2020 Corvette: Recall Notice: #N202309350: Non-Compliance - Interior Trunk Release Button Inoperative Ten Minutes After Power Off

Subject: N202309350 — Interior Trunk
Release Button Inoperative Ten
Minutes After Power Off

Models: 2020 Chevrolet Corvette

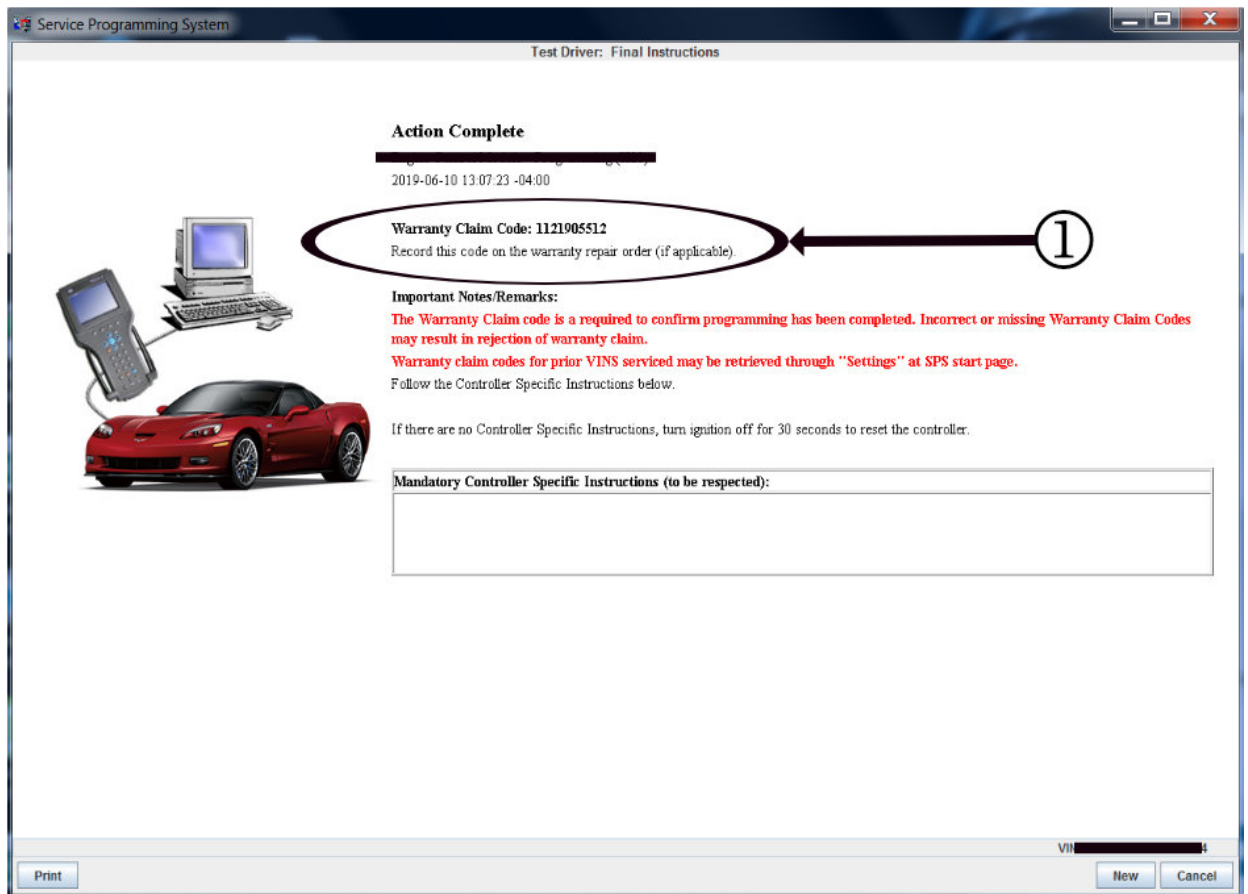
1. Reprogram the body control module. Refer to *K9 Body Control Module: Programming and Setup* in SI.
